Document 00910

ADDENDUM NO. Date of Addendum: \(\square\frac{\pi_{\infty}}{20} \)

PROJECT NAME: Almeda Road Paving and Drainage Improvements Old Spanish Trail to South MacGregor Way PROJECT NO: WBS No. N-000806-0001-4; CSJ No. 0912-72-072 BID DATE: May 28, 2015 J. Timothy Lincoln, P.E., City Engineer FROM:

TO: **Prospective Bidders**

Registration No. 1856

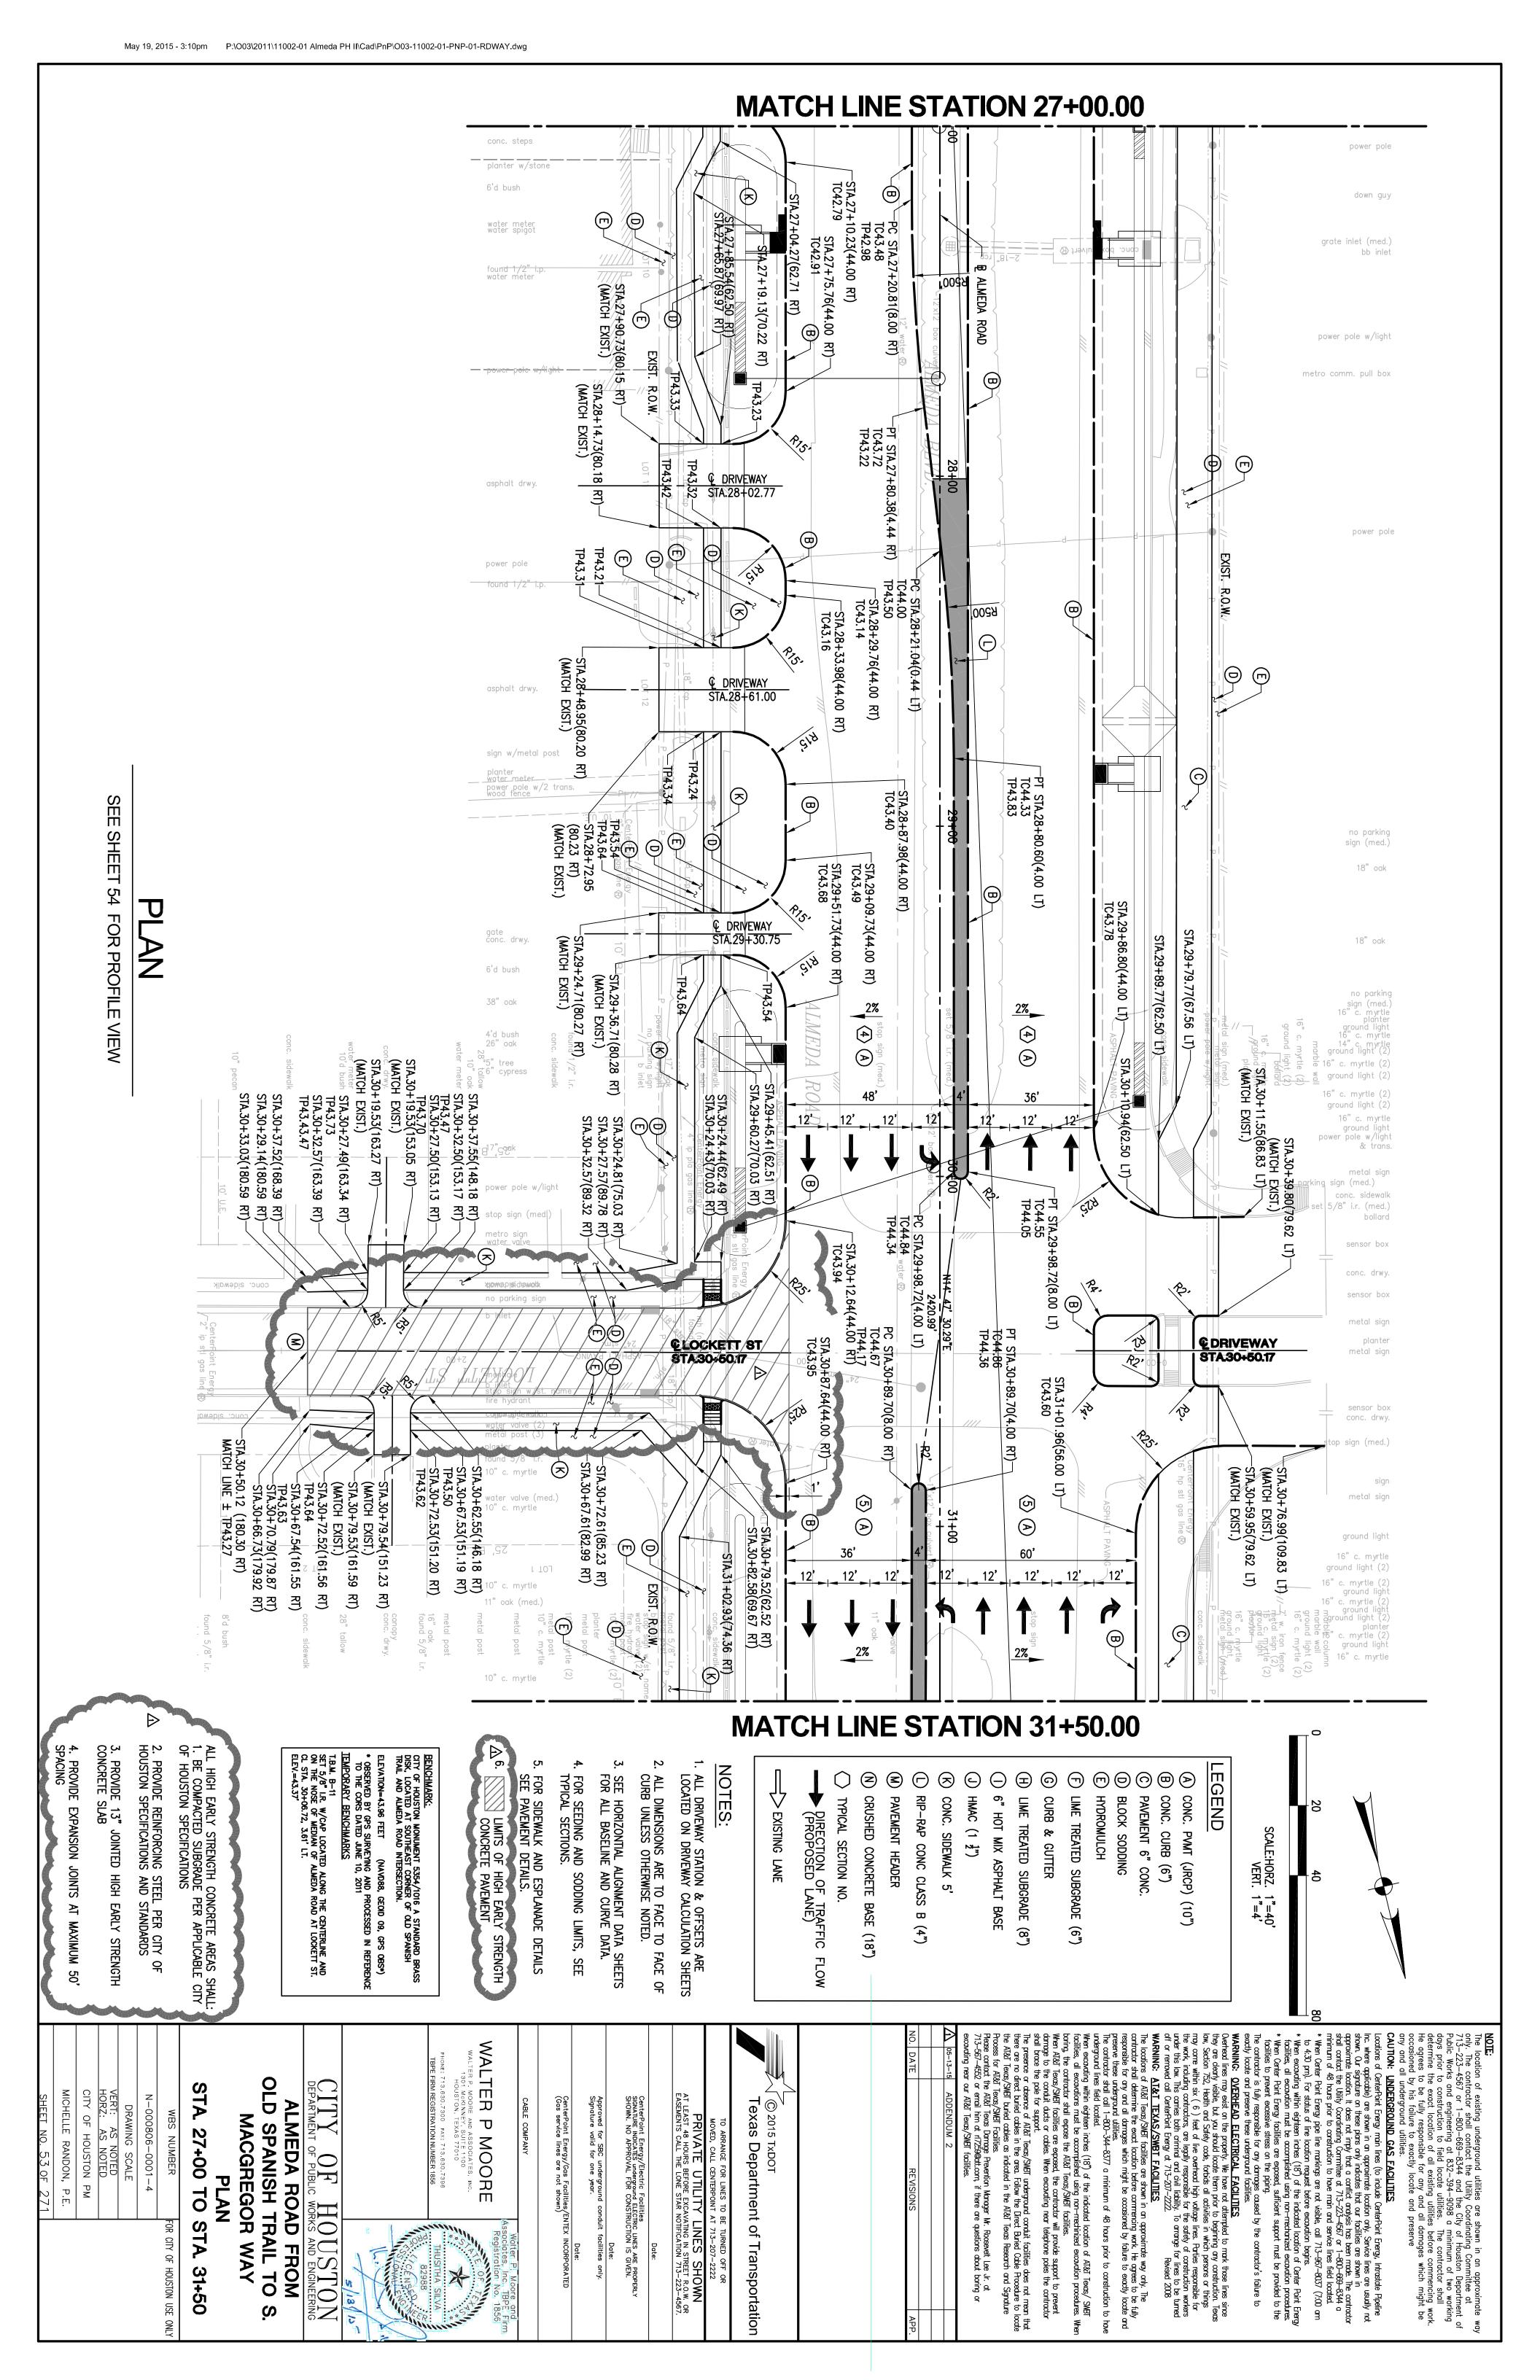
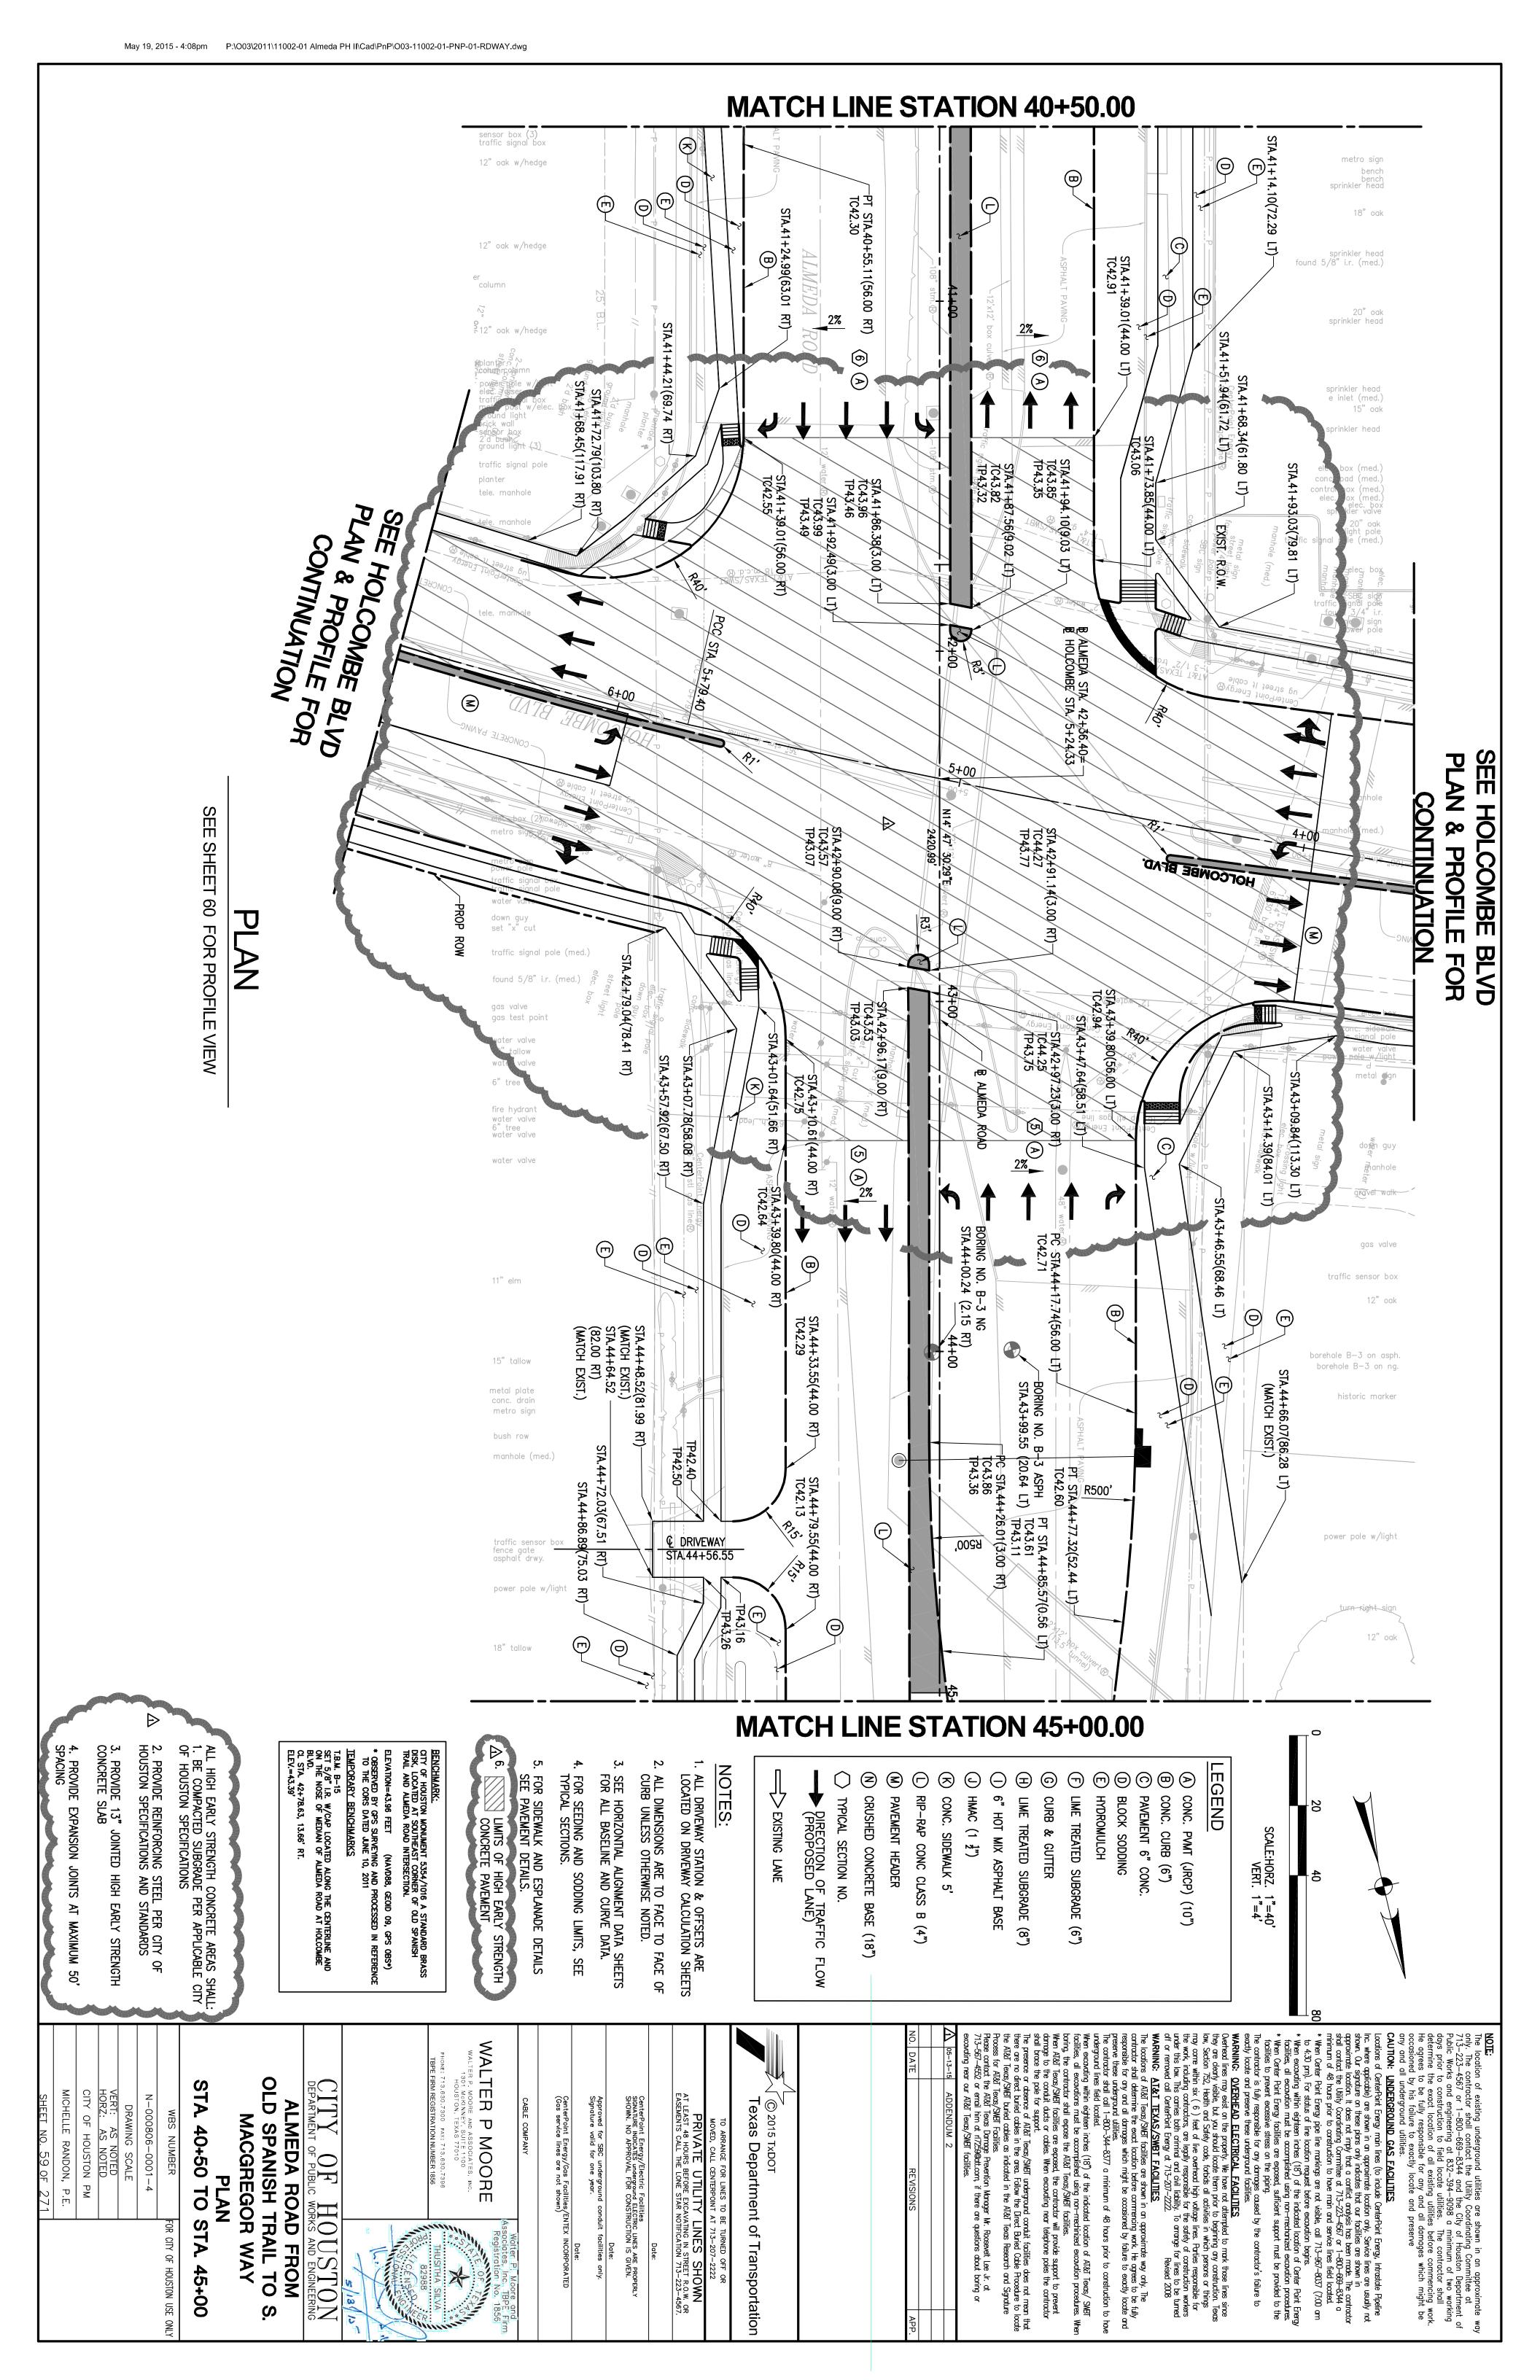
- 1. Sheet 21- Revised Holcombe Boulevard typical section, STA 6+37.98 to END PROJECT, to reflect added pavement and sidewalk reconstruction.
- 2. Sheet 22 Revised DEMOLITION QUANTITY.
- Sheet 22 A Revised STORM SEWER & STREET & BRIDGE QUANTITY
- 4. Sheet 47 Added driveway at station 16+04.59 & added shaded area to reflect limits of High Early Strength Concrete placement limits.
